PLAN COMMISSION AGENDA **Wednesday, June 26, 2024 at 7:00 PM**

Recommendation: Specific Implementation Plan for a mixed-use building at 1881 Springdale Street

The applicant is submitting for SIP approval for a mixed-use building consisting of 2 first floor commercial units with 23 apartments above. They received approval for their General Development Plan from the Plan Commission in April and the Village Board in May. The Village Board did not approve the height exemption for the roof of the building. Village Planner Ben Rohr has provided his review comments which are included in your packet.

1881 SPRINGDALE STREET		MT HOREB, DANE COUNTY, WI		Sheet C 300	
SITE PLAN		REVISION		BY	
		Checked By: CHKD		Scale: 1" = 20'	
		Engineer: SJA		Date: 05-24-2024	
		Technician: AJK		T-R-S: T6N-R7E-S7	
		Project No: 123.1425.30

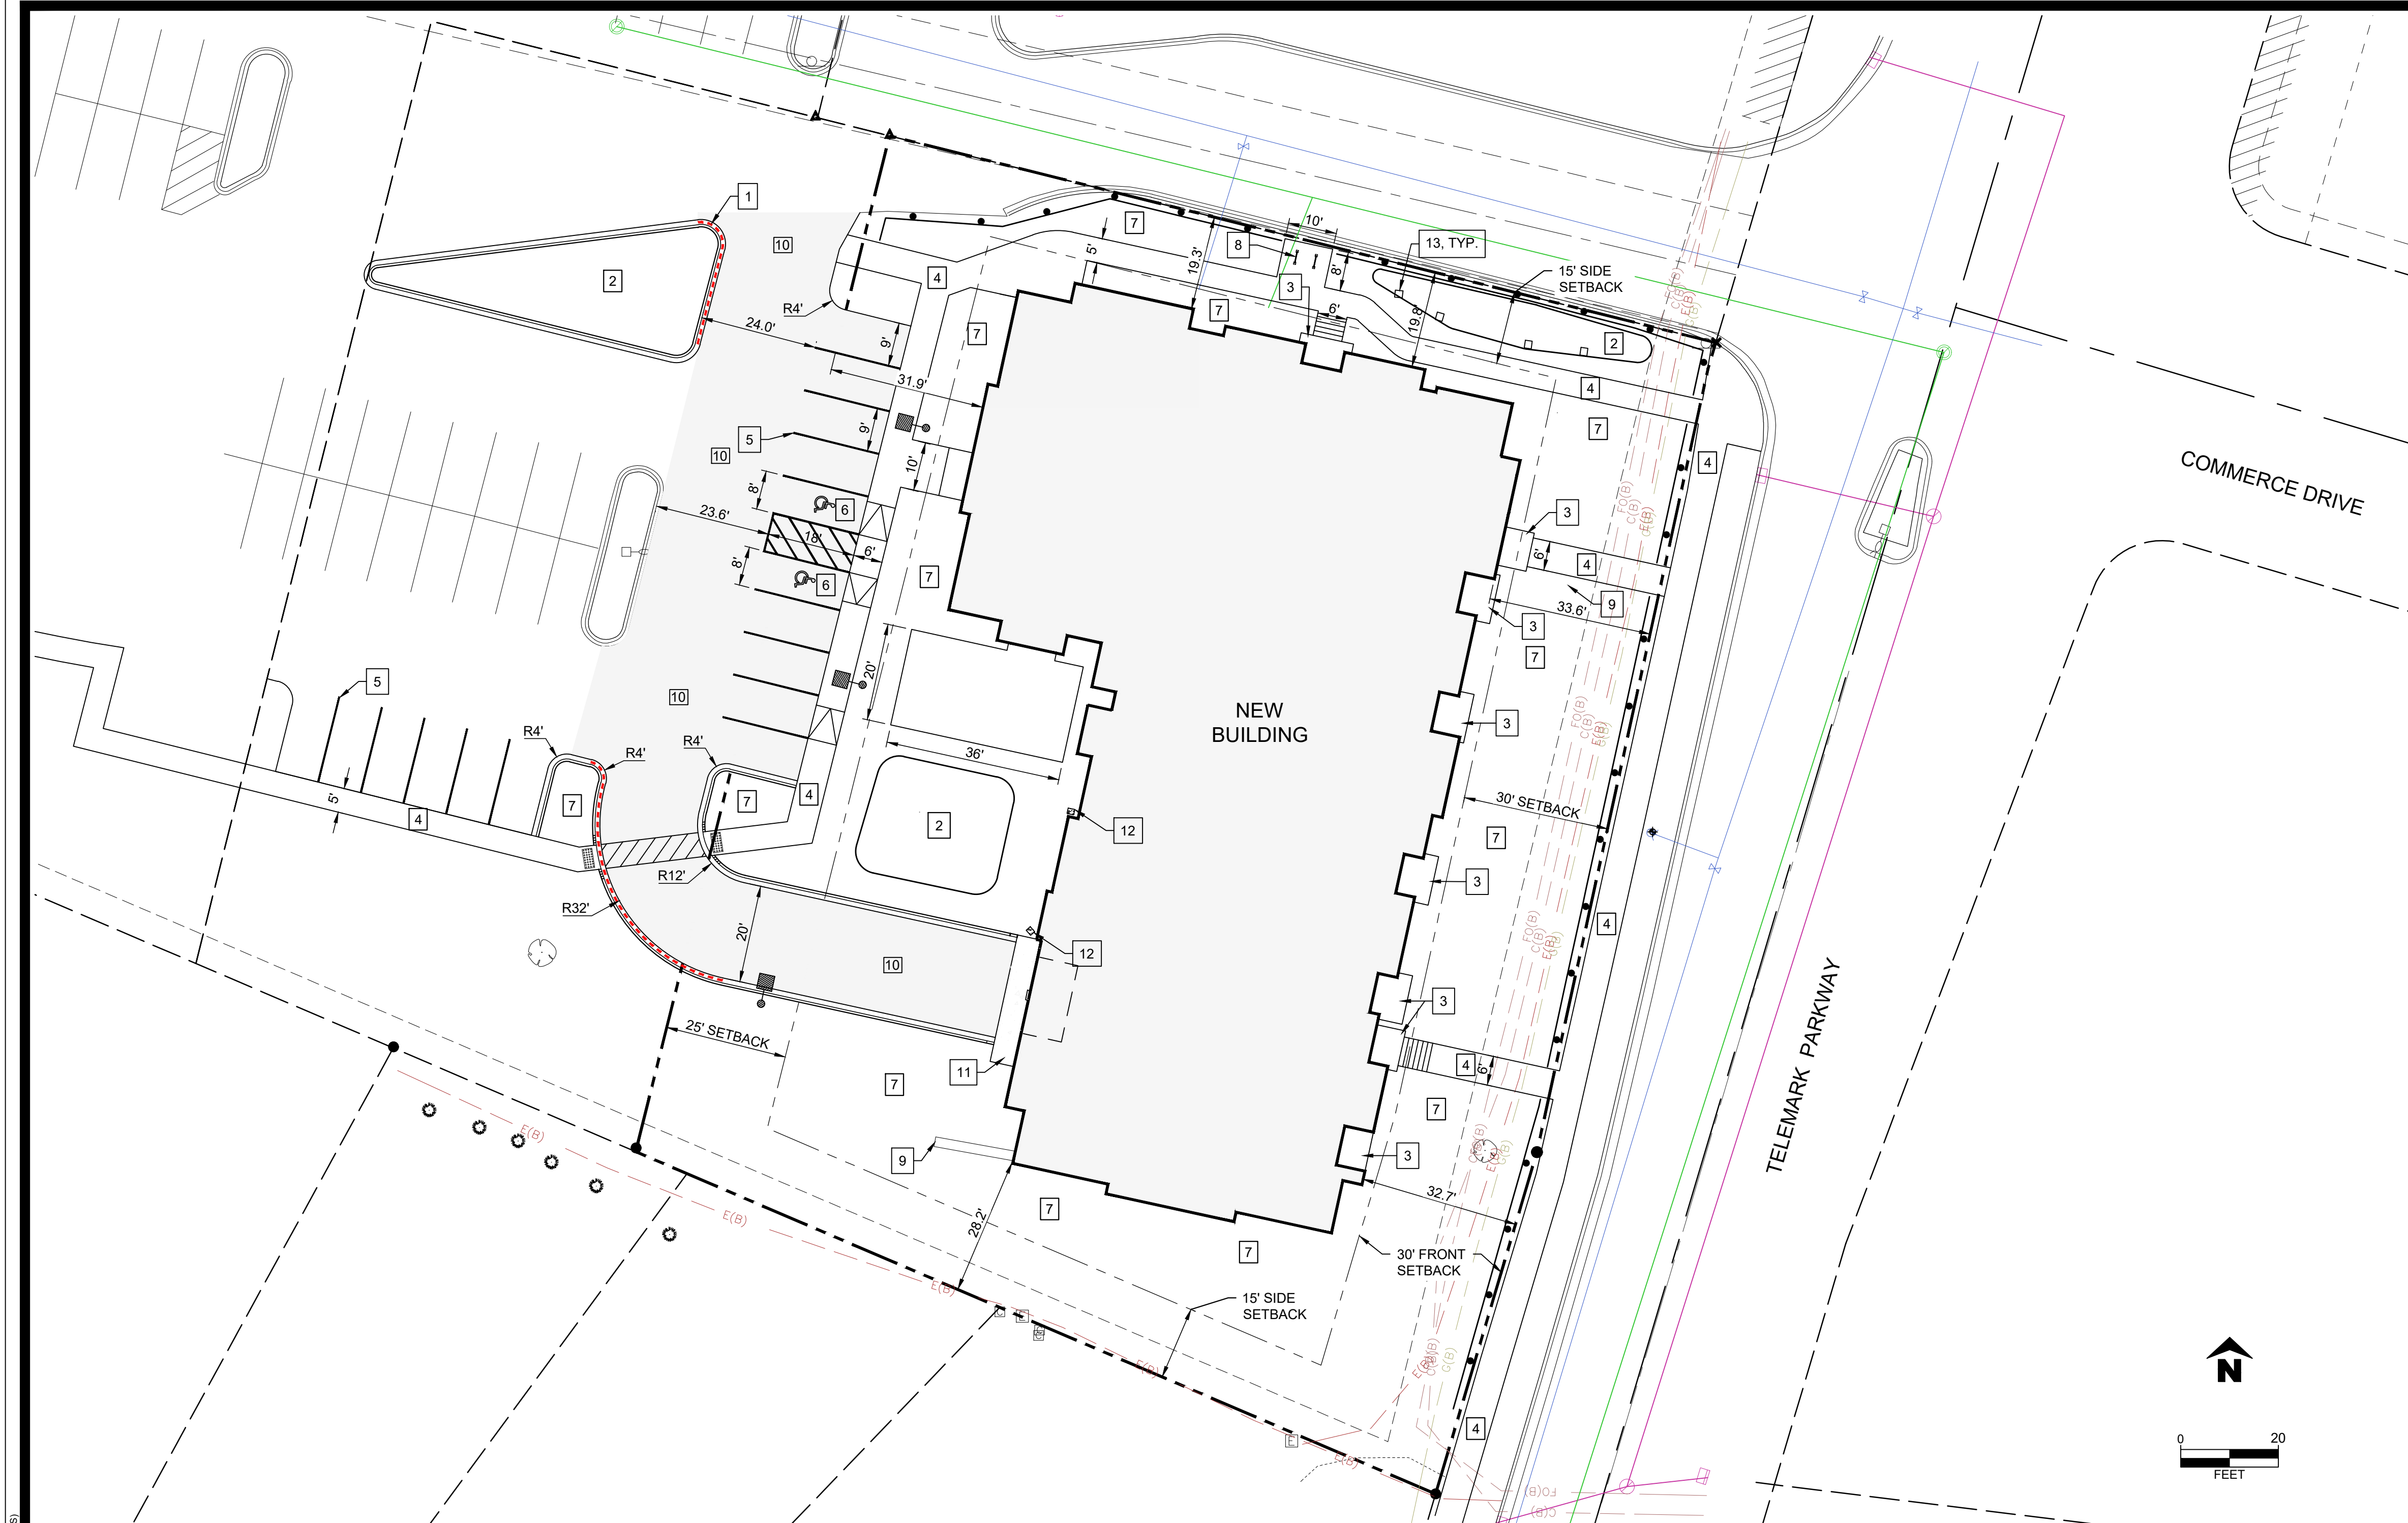
- Provide connectivity for pedestrians across the larger site (see submittal pages C-1.1 and C 300)
 - A pedestrian sidewalk connection is provided south of the building and shopping center parking areas to connect the proposed mixed-use building to the grocery store.

C-2.1

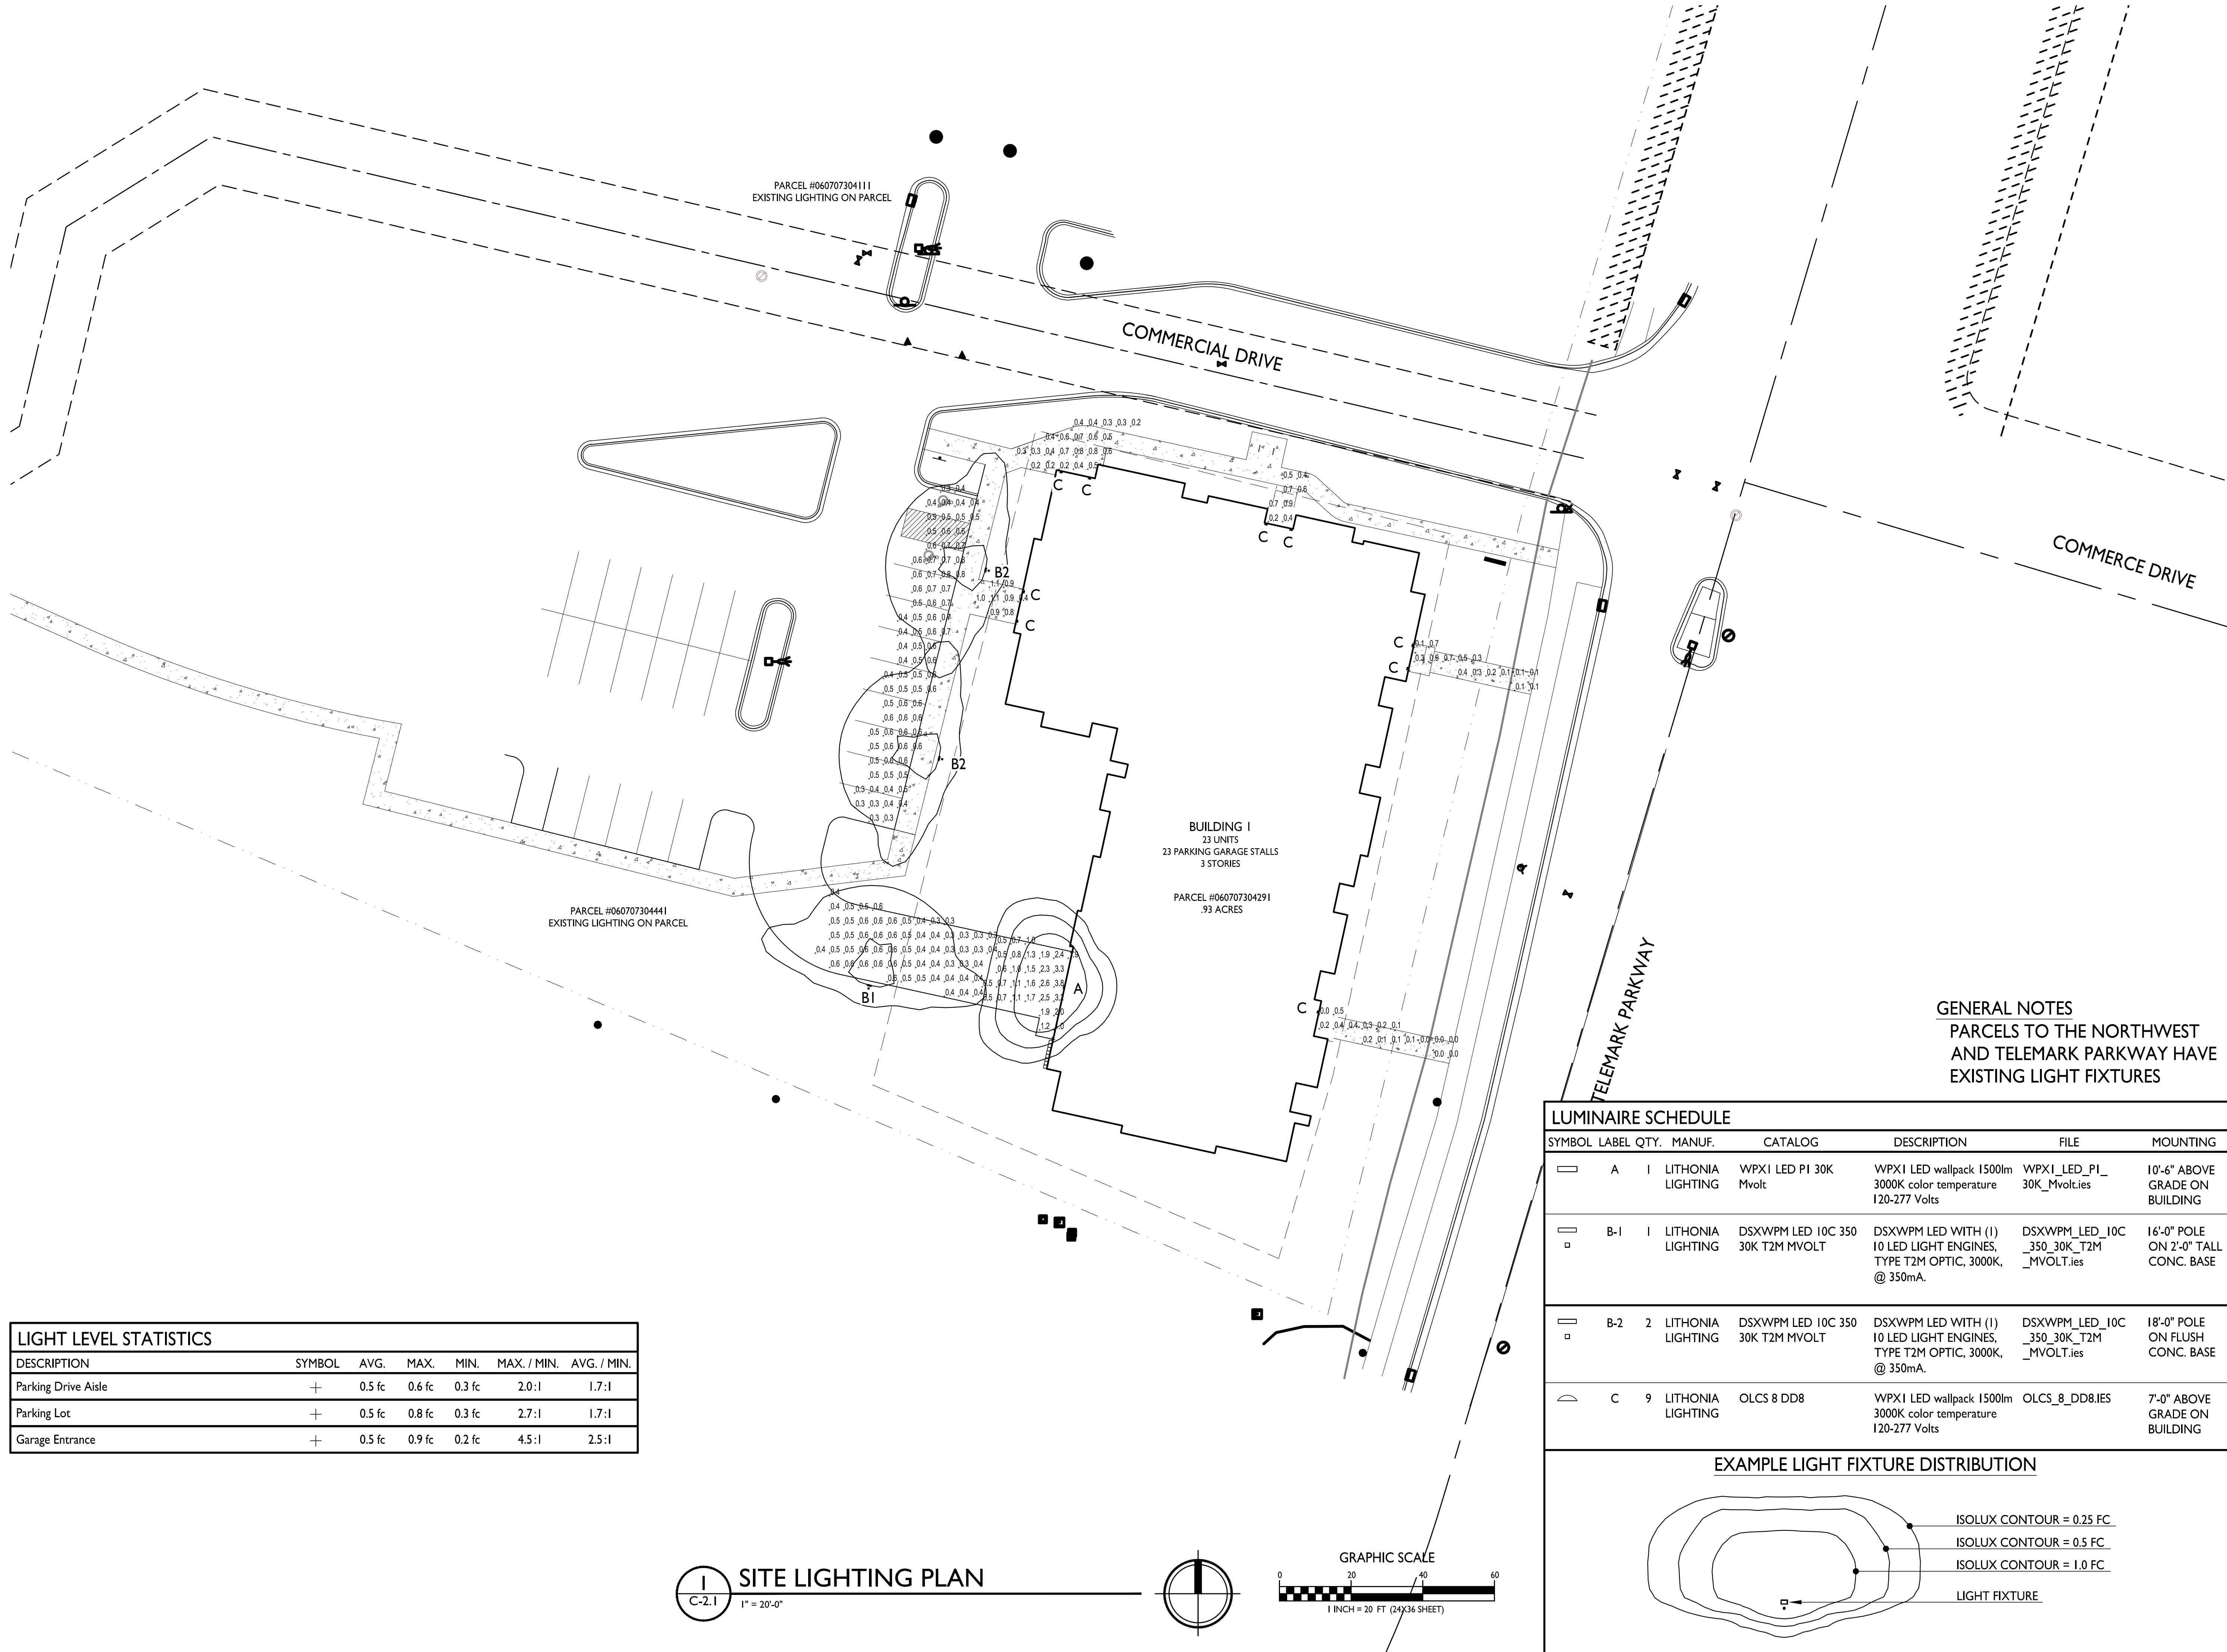
Bike Parking: On Sheet C-1.1, two biking parking stalls are shown on the north side of the building. A minimum of 6 will be required for the development. Please include additional bicycle parking within the plans and if any are planned to be outside of the building, please include an elevation view plan.
